Memo

To: Cheryl Low, Matakanui Gold, Environmental Manager
From: Jens Rekker, BOGP Kōmanawa Solutions' Assessment Manager
Date: 30 January 2026
Subject: Responses to ORC Technical Review in terms of the Fast-Track Approvals Act and RMA

The Bendigo – Ophir Gold Project (BOGP) is a multiple pit and workings mining complex proposed by Matakanui Gold Ltd, the New Zealand subsidiary of Santana Minerals Ltd. The proposed mining complex is located in the Dunstan Mountains of Central Otago, on the western flanks of the range overlooking the Bendigo agricultural / horticultural district and nearby historic mining area.

Figure 5: Drawdown under scenario 6, where a drawdown up to 2 metres is applied by elevated pumping

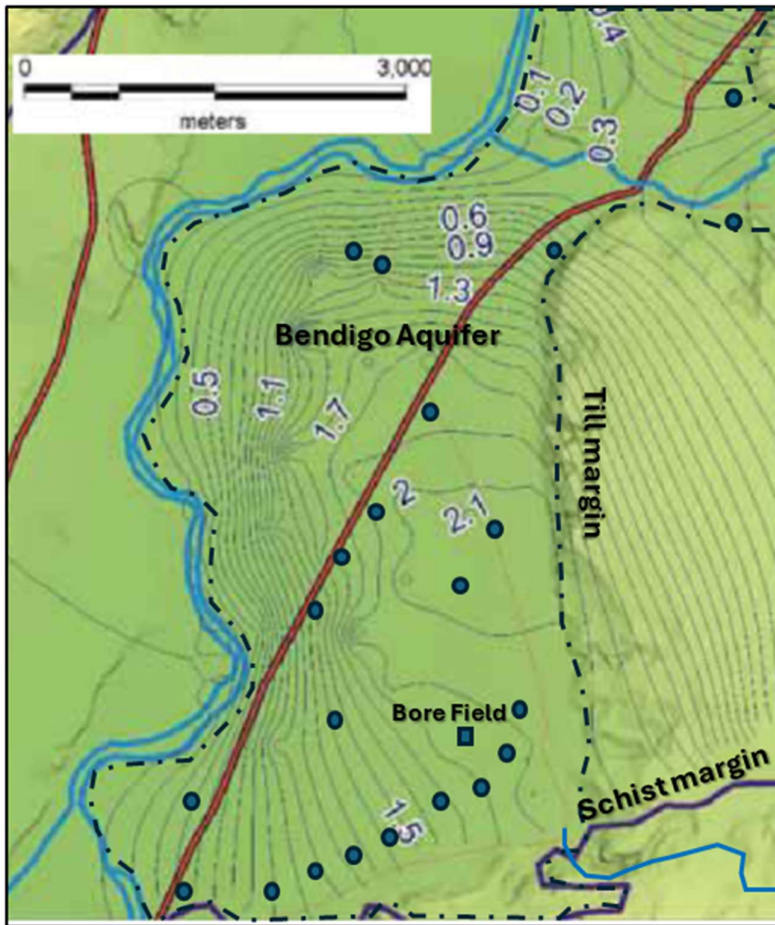
The e3 reviewer noted that among the aforementioned shortcomings of the aquifer tests (as conducted) was the lost opportunity to detect the hydraulic effect of barrier to groundwater flow (sink) boundary condition, presumably as artefacts in the late-time drawdown trends. While theoretical understandings of aquifer and aquifer tests suggest that the harder the bore is pumped and the longer that the aquifer water levels are monitored while pumping, the higher the probability that such artefacts of the surrounding aquifer margins could be detected from within the drawdown measurement at monitoring bores. While I accept the theoretical proposition and this is among the reasons for Environment Canterbury’s groundwater section specifying 72 hours as the minimum within large aquifer tests in that region’s guidelines, the minimum duration does not confer a guarantee that barrier boundary effects will be detected. Accordingly, I am of the view that even had the aquifer test have been conducted as per the guidelines it would have been unlikely to have gained useful indications of lateral barriers.

Figure 5 reproduces Figure 5.9 from page 36 of the Houlbrooke report in setting the groundwater allocation for the Bendigo Aquifer. Figure 5 provides contouring of model groundwater level under the describe model regime of Scenario 6. This simulation suggested that steady state modelled pumping across the Bendigo Aquifer at the marked irrigation bores would rest at 58 million cubic metres per annum (approximately 1,843 L/s). The current consented groundwater take total for the Bendigo Aquifer is held by ORC to be 16,225,855 cubic metres per annum (16.23 million m³/year).

It should be noted that Scenario 6 included nine simulated irrigation bores closer to the southeast corner of the aquifer than the proposed BOGP bore field (marked with blue square and “Bore Field” in Figure 5). Each of these bores would have been simulated with a pumping rate of more than 90 L/s in Scenario 6, approximating the proposed long-term pumping rate of the BOGP water supply bore field.

Figure 13: A comparison of measured and modelled heads for Come In Time (CIT) pit area

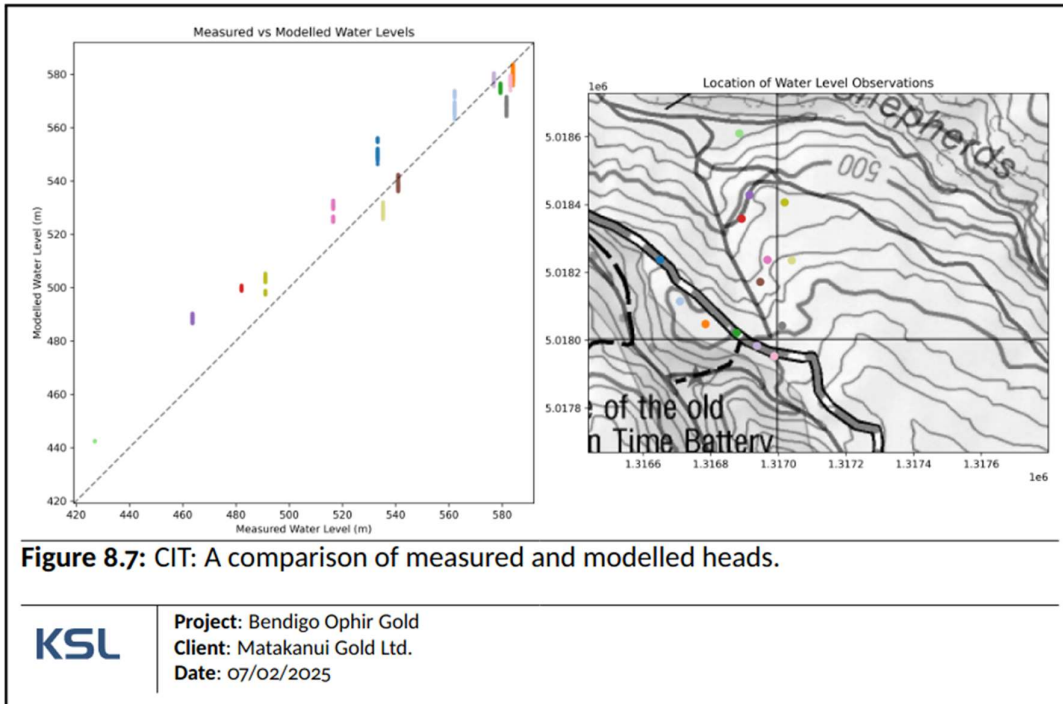
It has been noted by the ORC reviewer that the models "underestimates head in the vicinity of pits, and overestimates (head) in areas of discharge". It is questioned whether this gives rise to model bias in estimating groundwater drawdown and stream depletion using the same models. Firstly, it is worth pointing out that the (head) observation points used for all three models are open hole resource exploration bores with no casing,

The reviewer is correct for the RAS and CIT models that there is typically an underestimate of heads on the convex ridge tops and an overestimate of heads on the steeper flanks. We have discussed this in the model report:

Essentially, we believe that in the steeply incised area there is likely to be significantly lower recharge from the veneer aquifer¹². The stream depletion assessments for both the CIT and RAS mines show that there is no direct depletion of Shepherds creek. For the CIT model the excavation never reaches the elevation of Shepherd's creek, so direct depletion is impossible. For the RAS model, while the pit does extend below the elevation of the creek, the very low conductivity of the TZ-3 material prevents direct depletion¹³. None of the model results showed any direct depletion. This is further supported by the very conservative estimates of stream depletion from the underground workings, which yields a negligible direct depletion (see Section O). Therefore the stream depletion impacts of both of these features are limited to the intercepted rainfall, runoff, veneer aquifer flow, and recharge. For both the CIT and RAS mining activities we bounded the possible impact of intercepted flow *via* a catchment rainfall analysis, which is independent of the models. Additionally while there are significant model misfits a steep topographic and head gradient remains within each model. Despite the head misfits the steep gradient is largely maintained. For instance in the CIT observations below, the valley bottom heads are overestimated by c. 10 m, but this yields a gradient between the next upslope observation of c. 440m to 490m instead of the correct gradient of c. 430 m to 460 m.

This valley bottom observation is the only observation that is not in the mining area and/or directly adjacent to mining activities for RAS and CIT. The general over-estimate of the valley side heads in the pit areas of the CIT and RAS means that the estimated drawdown is higher than it is likely to be and this should yield a higher flux into the pits from these areas. The underestimates at the top of the ridges will underestimate drawdown but given their high elevation and the very low conductivity it is unlikely that the underestimate will yield significantly increased inflows to the pit and certainly will not exceed the rainfall based estimates from a conservatively sized catchment.

Figure 15: Footprint of Model Zones of RAS Underground Workings (left) vs Actual Proposed Workings (right)

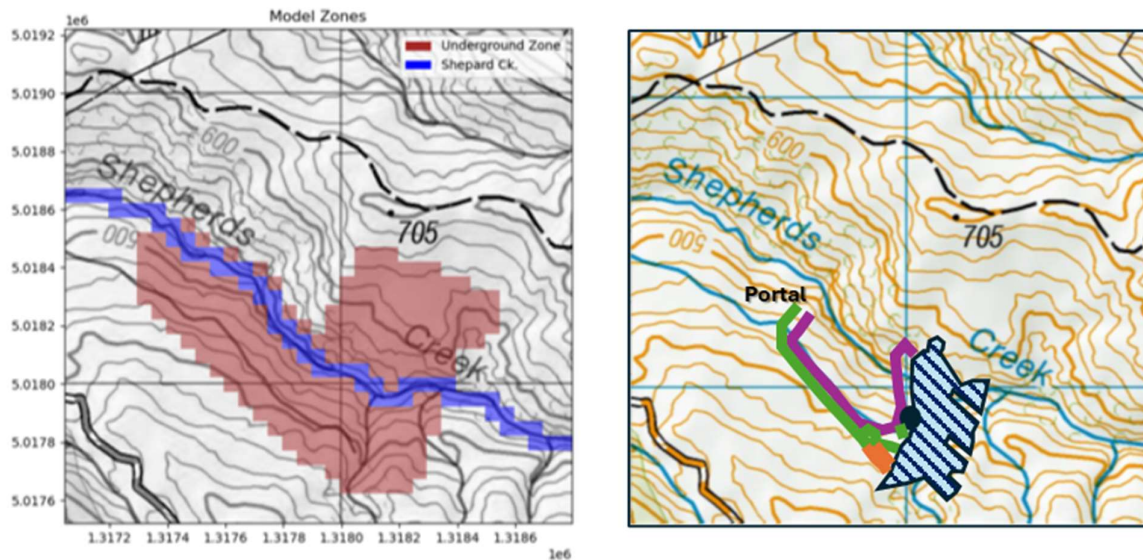
Question 3: *Please assess the stream depletion effect of the RAS underground mine.*

Response to Question 3: The modelled stream depletion on Shepherds Creek of the RAS Pit was largely by intercepting hard-rock groundwater that would otherwise have made its way to the creek bed *via* the groundwater system. The groundwater interaction with the RAS underground workings is quite distinct from the pit. A minimum of 250 metres of saturated TZ-3 schist intervenes between the creek bed and top of the underground tunnels network. A special semi-generic model was developed for responding to Question 3, above. As the previously calibrated and optimised bulk hydraulic conductivity of this schist material was in the range of 3×10^{-7} to 3×10^{-5} m/day (3.5×10^{-12} to 3.5×10^{-10} m/sec), the modelled depletion effect on Shepherds Creek of tunnel dewatering would be negligible, generally in the order of a hundredth of a litre per second but less than 1 litre per second.

To assess the possible stream depletion effects of the underground workings of the Rise and Shine Mine we produced a very simple model conceptualisation. The underground workings are a combination of access / service tunnels and stope zones. The stope zones are to be backfilled with cemented tailings paste as described in the principal application technical document, so these individual zones would not remain as voids for long perhaps a month. The tunnels are longer-term features and to maintain safe and serviceable tunnels, dewatering with out-pumping to the surface would be required long-term (Year 6 to Year 13). For these reasons, the estimation of predicted dewatering and potential for depletion impacts on Shepherds Creek is limited to the tunnel zone of the underground workings.

Instead of assessing the detailed underground workings we have instead created a “underground workings zone”, which contains the potential workings, but is much larger than the total plan view area of the underground workings (see Model Zones figure).

We then created a simplified 3-layer model. The model top elevation is assumed to be flat (0 m). Layer 1 is 1m thick with constant head cells in all model cells that intersect Shepards Creek (Blue in Model Zones figure). There are no additional boundary conditions in layer 1.
